Proposal how to structure the RESS safety requirements

Diagram 1 – minimum shock pulse

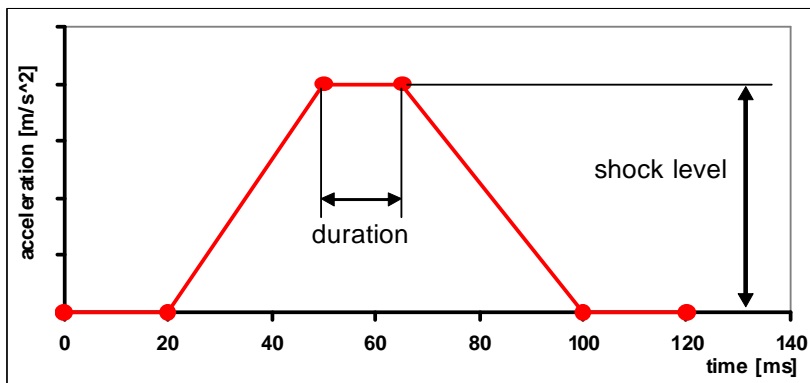
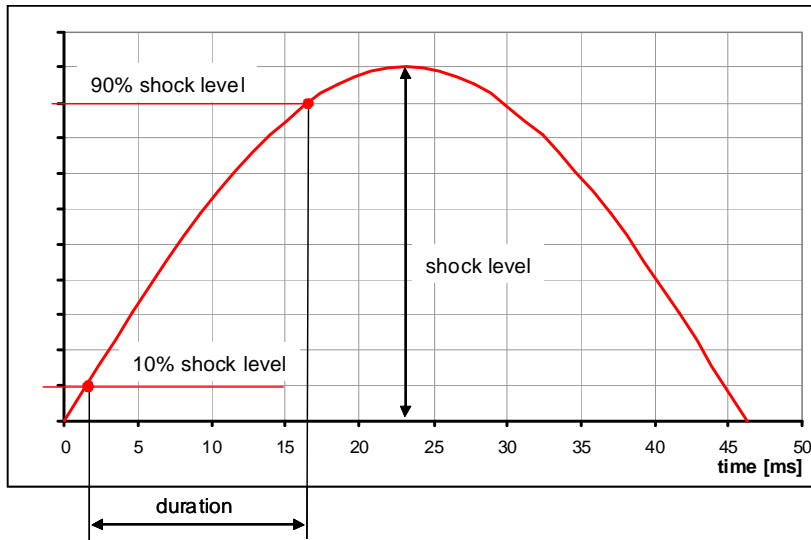
Comment [T57]:
Comment Sweden
Acceleration pulses in Diagramm 1 and 2 do not represent acceleration pulses equivalent to acceleration pulses generated in a R94 crash test with modern vehicle

Diagram 1
M1, N1 Shock levels and duration in direction of travel

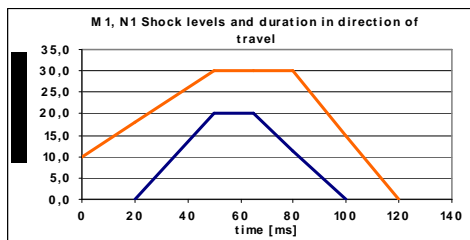
Comment Continental:
Define a corridor (lower and upper limit) for the acceleration in diagram 1

Figure 1

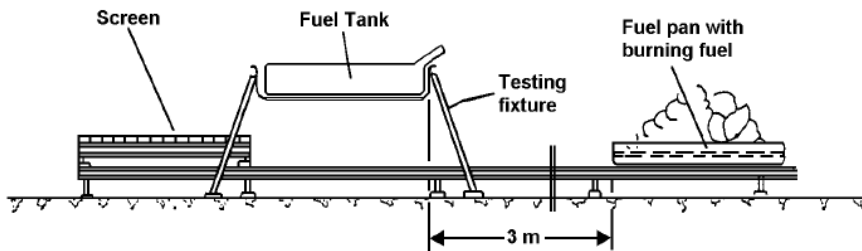
Comment [T84]:
Comment Continental
Delete paragraph 3.4.2.1.8.1 to simplify the test and avoid moving burning fuel.

Figure 2

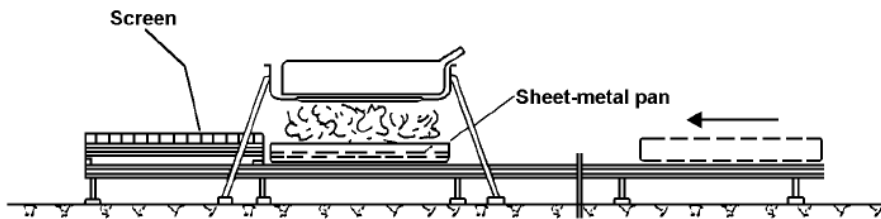
Comment [T86]:
Comment Continental
To compensate for deletion of paragraph 3.5.2.1.7.1 the burning time shall be fixed to 90 seconds.

For ~~90~~ 70 seconds the [RESS] shall be exposed to the flame from the freely burning fuel.

Figure 3

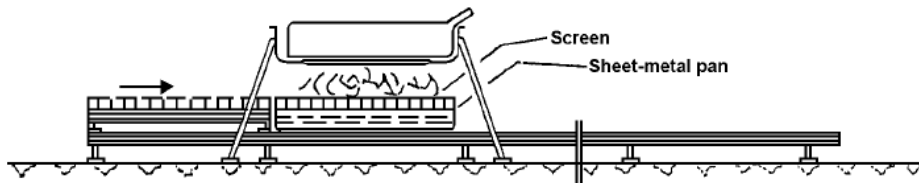
Comment [T88]:
Comment Continental
 As Phase C is not influenced by changing initial Phase A and B, we shall stick to the initial 60 seconds burning time.

Comment [T89]:
Comment Continental
 As Phase C is not influenced by changing initial Phase A and B, we shall stick to the initial 60 seconds burning time.
